SUBJECT: LANDING GEAR SAFETY SWITCH OVERRIDE

MODELS AFFECTED: M20C 700055 thru 20-1233
 M20E 700035 thru 21-1180
 M20F 700038 thru 22-1441
 M20J 24-0001 thru 24-0237

TIME OF COMPLIANCE: At owner's discretion.

FIG. 1A

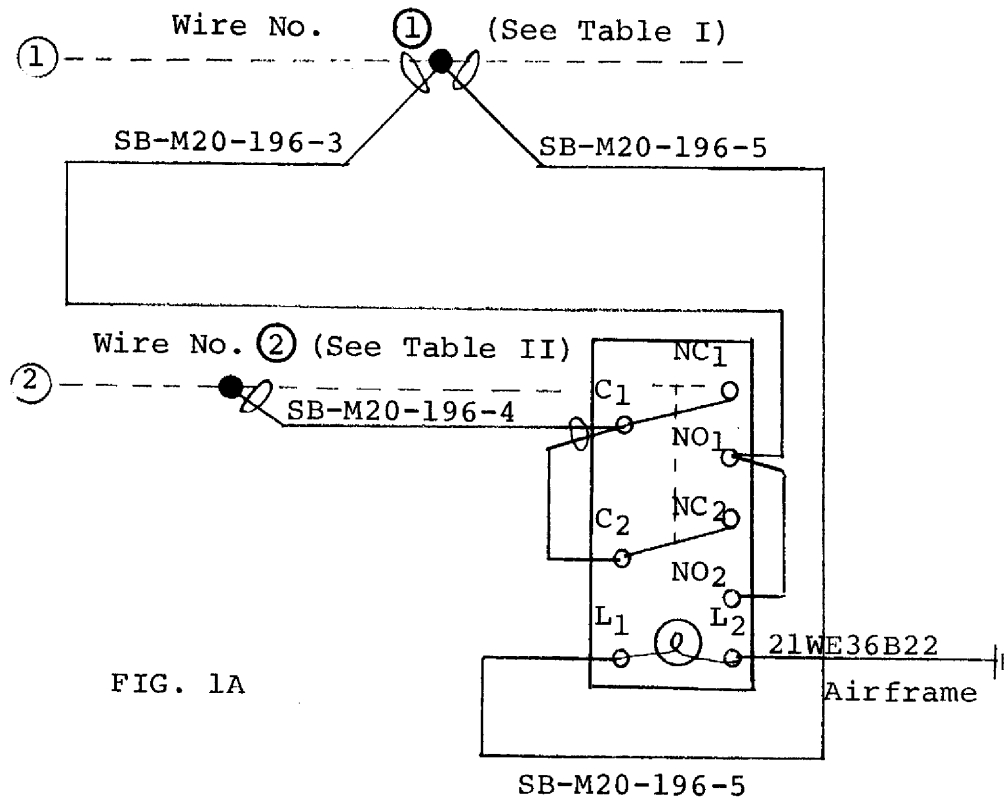
For those aircraft with a single relay system that have not been modified as per Service Instructions M20-34A or M20-34B, the following change needs to be followed:

Wire No. (SB-M20-196-5) and wire no. (SB-M20-196-3) are to be installed together at wire no. ①

FIGURE I

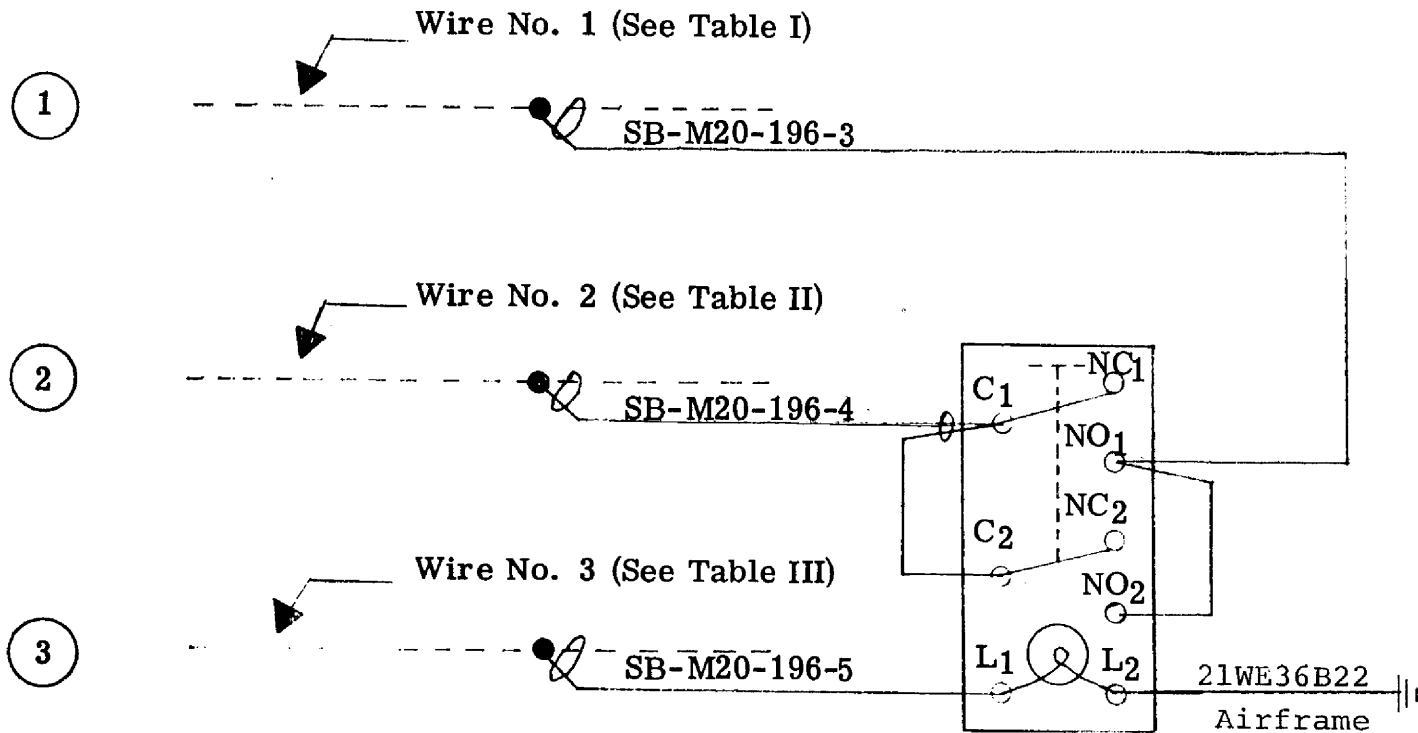
- (4) Locate wire ① (see Table I for wire, plug, and pin numbers for your aircraft). Cut 6 to 12 inches from plug and splice in wire SB-M20-196-3 using window splice supplied. (See Figure I).

- (5) Locate wire ② (see Table II for wire, plug, and pin numbers for your aircraft). Splice in wire SB-M20-196-4 as in step (4). (See Figure 1).
 - (6) Locate wire ③ (see Table III for wire, plug and pin numbers for your aircraft). Splice in wire SB-M20-196-5 as in step (4). (See Figure 1).

FIGURE II

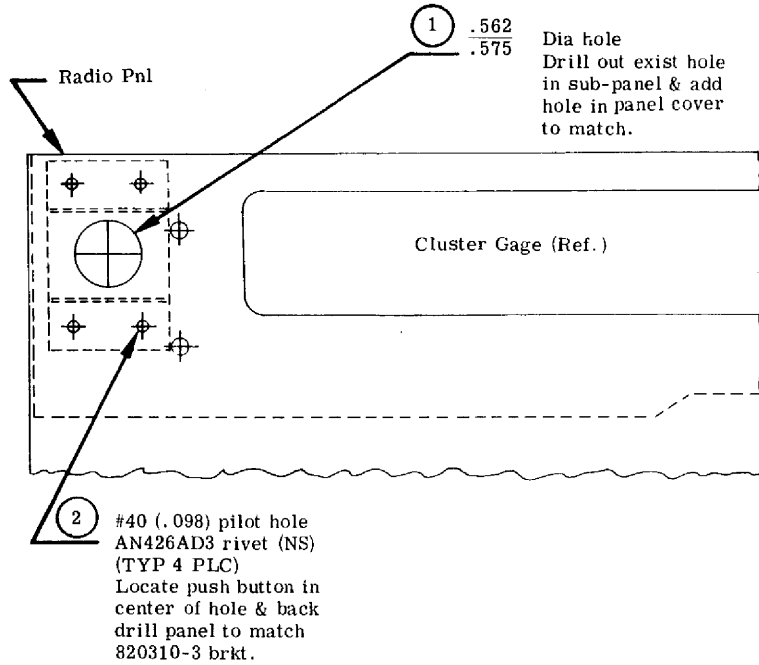
- (3) Install by-pass switch assembly in panel per Figures II thru V. Connect ground wire #21WE36B22 to airframe ground. (Select figure applicable to your serial number aircraft.) Route and secure wires SB-M20-196-3, SB-M20-196-4, and SB-M20-196-5 with existing wire bundle forward to firewall and down to left wing plug.
